Final Work Plan

Ash Landfill Biowall Recharge
Seneca Army Depot Activity

Army's Response to Comments from the New York State Department of Environmental Conservation

Subject: Draft Work Plan for the Ash Landfill Biowall Recharge at Seneca Army Depot
Seneca Army Depot Activity
Romulus, New York

Exhibit 4.1
Drilling and Injection Costs (not including injection materials)
Versus Well Spacing

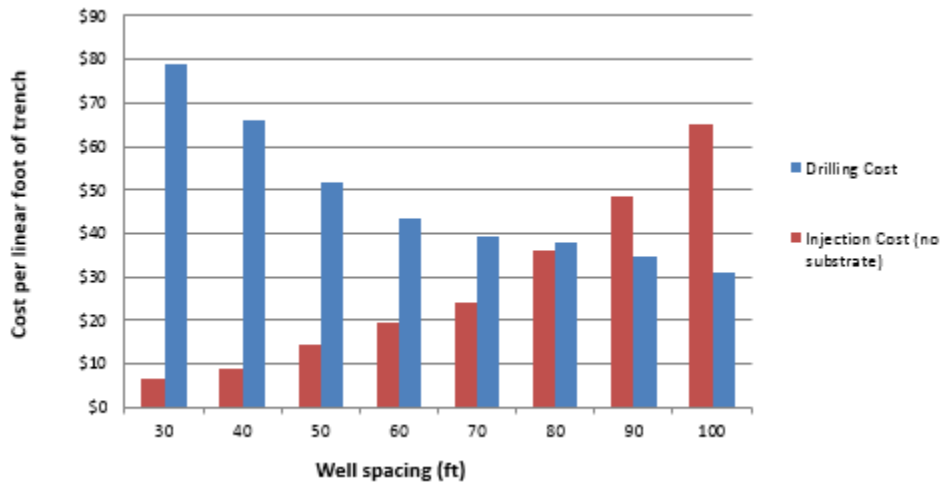
Comment 2: Section 4.1.2: I question whether the 80 to 90-foot spacing between the recirculation wells may be too much space between the wells to be effective.

Response 2: The principles and practices manual (which was prepared by Parsons) is focused on applying enhanced bioremediation in natural media (injection into saturated soil) where substrate distribution away from an injection well is radial because the subsurface media is generally homogeneous. In a natural media setting, a 90-foot injection well spacing would require huge injection volumes and would not generally achieve the desired results. In the case of the Seneca Ash Landfill, we are refreshing a biowall which is generally a linear structure of very high permeability material installed in soil of comparatively low permeability. Thus, during injection (and extraction) substrate distribution will be forced along the trench radically increasing distribution in the "along trench" direction and in the direction of the extraction well. Reference page 5-11, section 5.4.2, Recirculation of the Principles and Practices of Enhanced Anaerobic Bioremediation of Chlorinated Solvents (2004) where it states "Highly permeable and uniform lithologies are required to use well spacings on the order of 50 to 100 feet."

Figure 4.1 Biowall Recirculation Proposed Well Locations

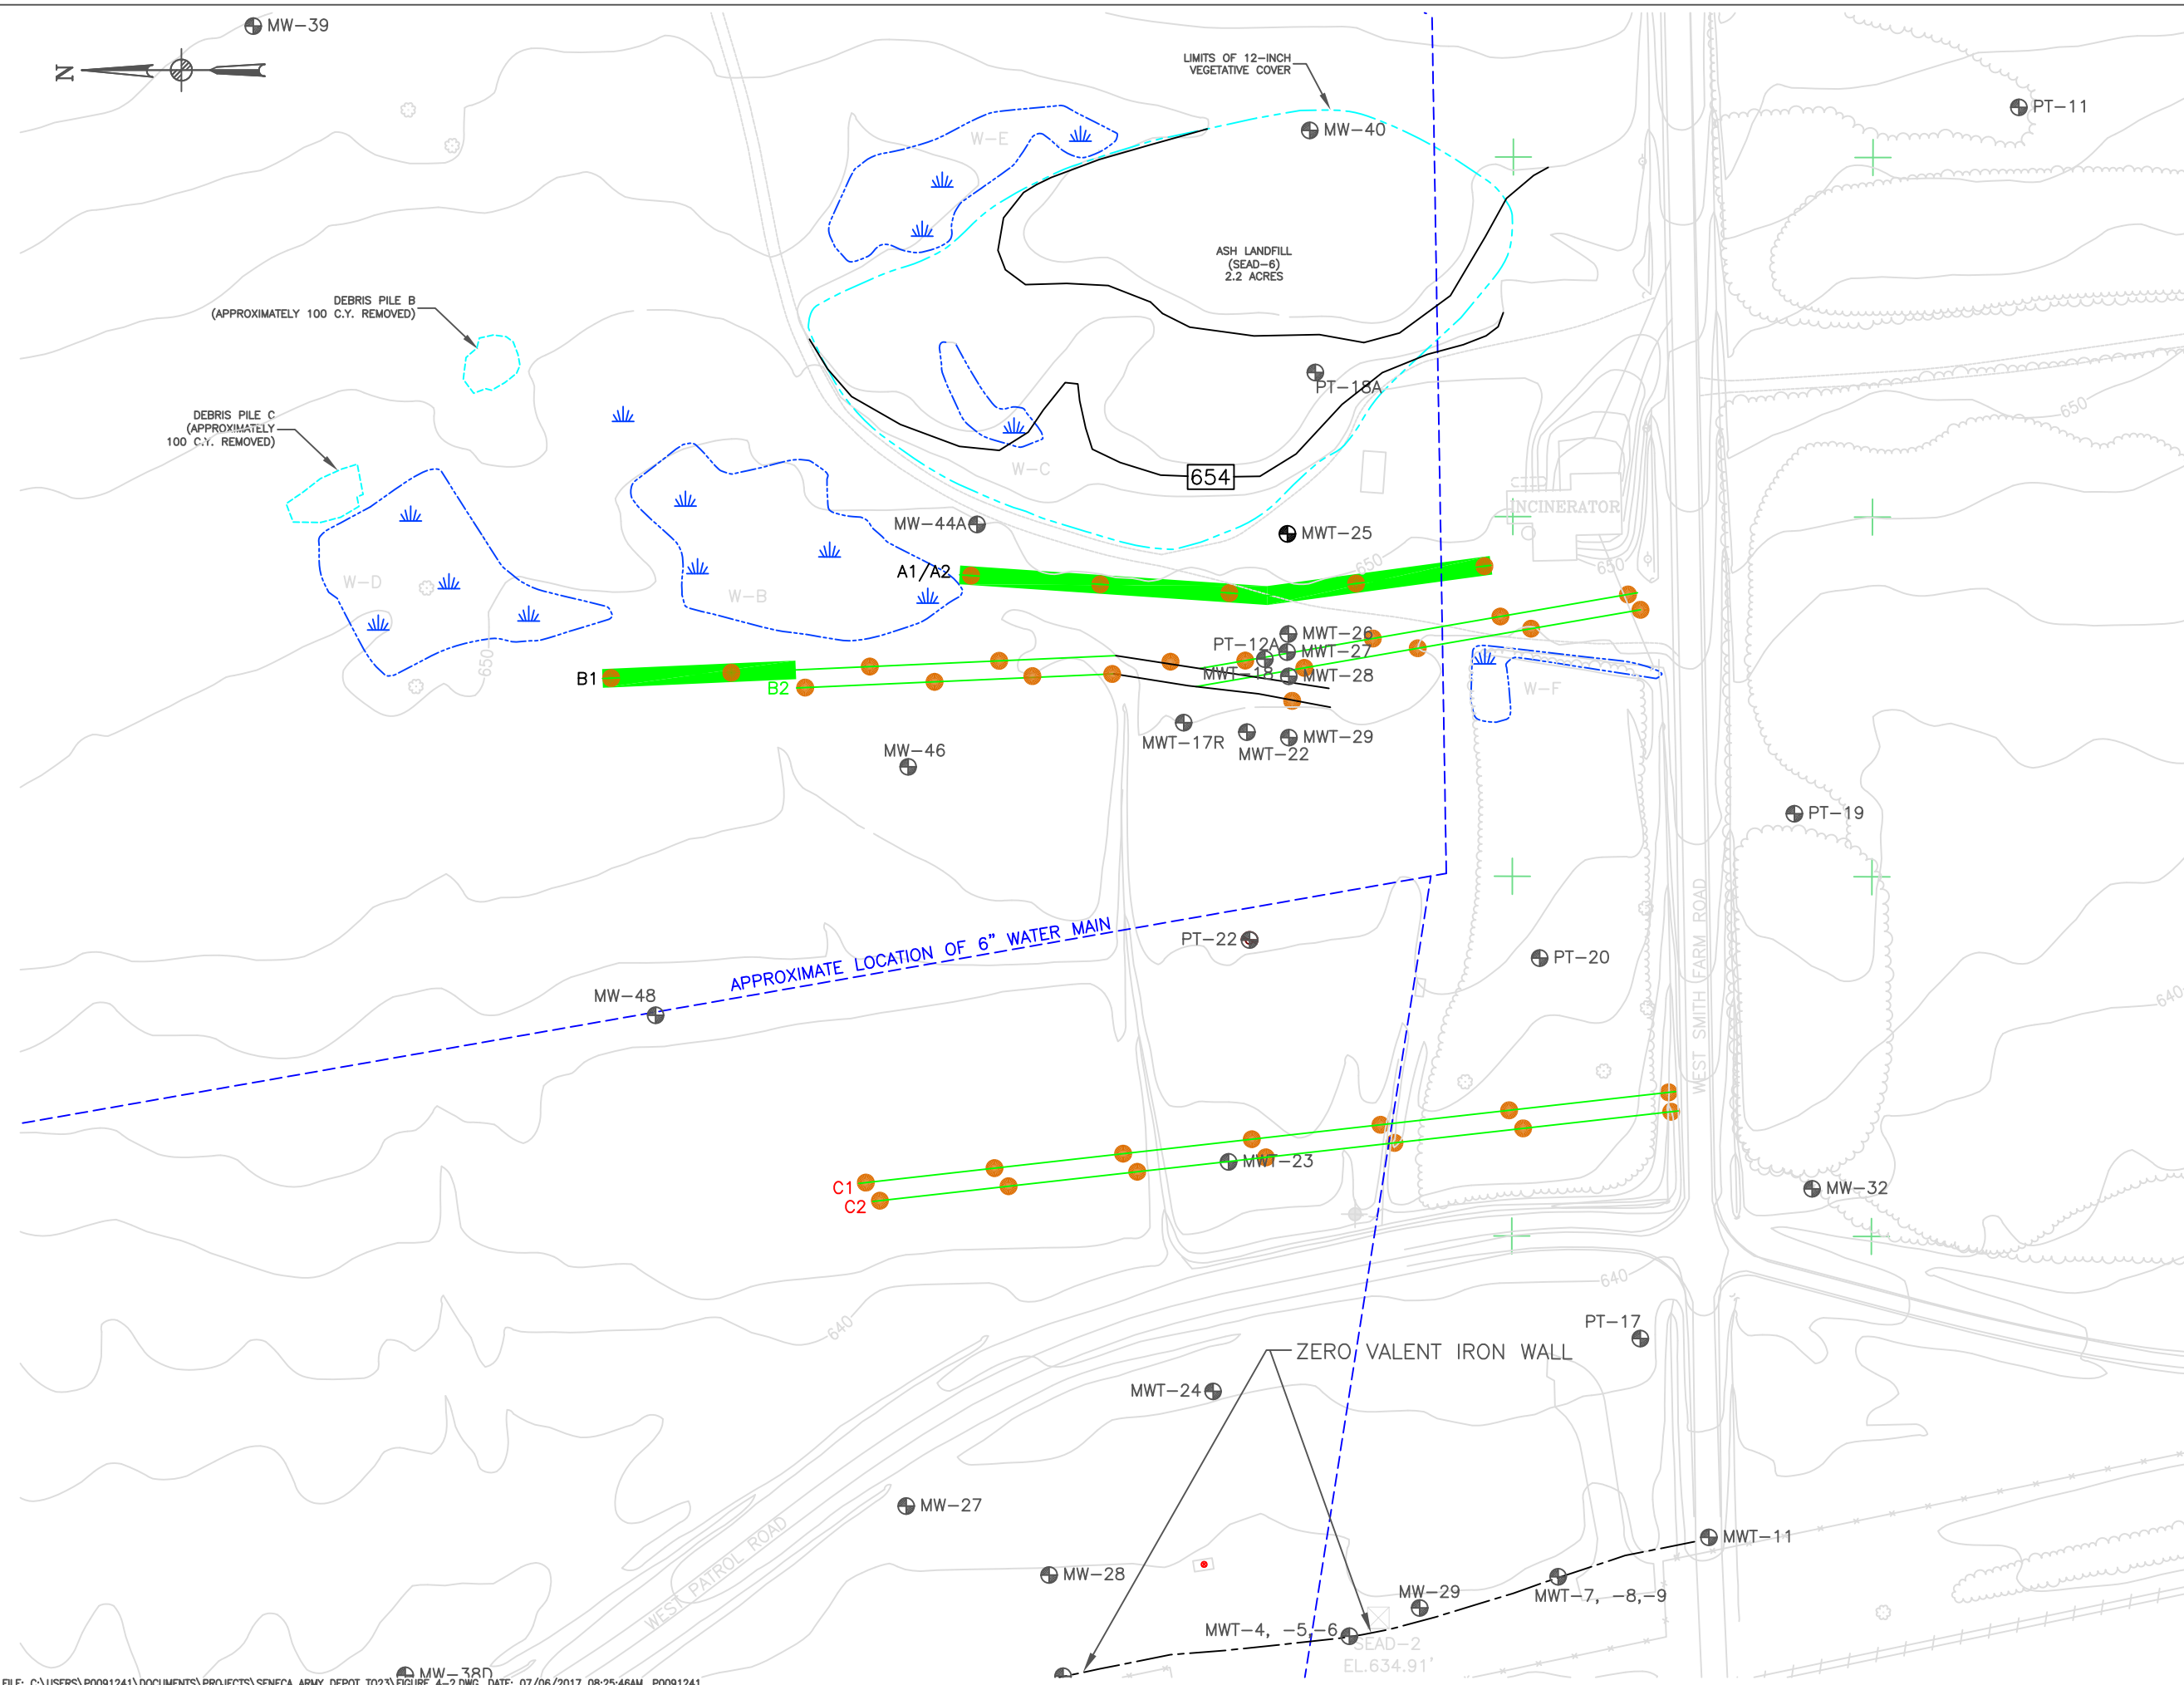
Comment 3: Table 4.1: The number of wells in B1/B2 is inconsistent between the Figure 4-1 and Table 4.1.

Response 3: The figure was revised so that it is consistent with Table 4.1.
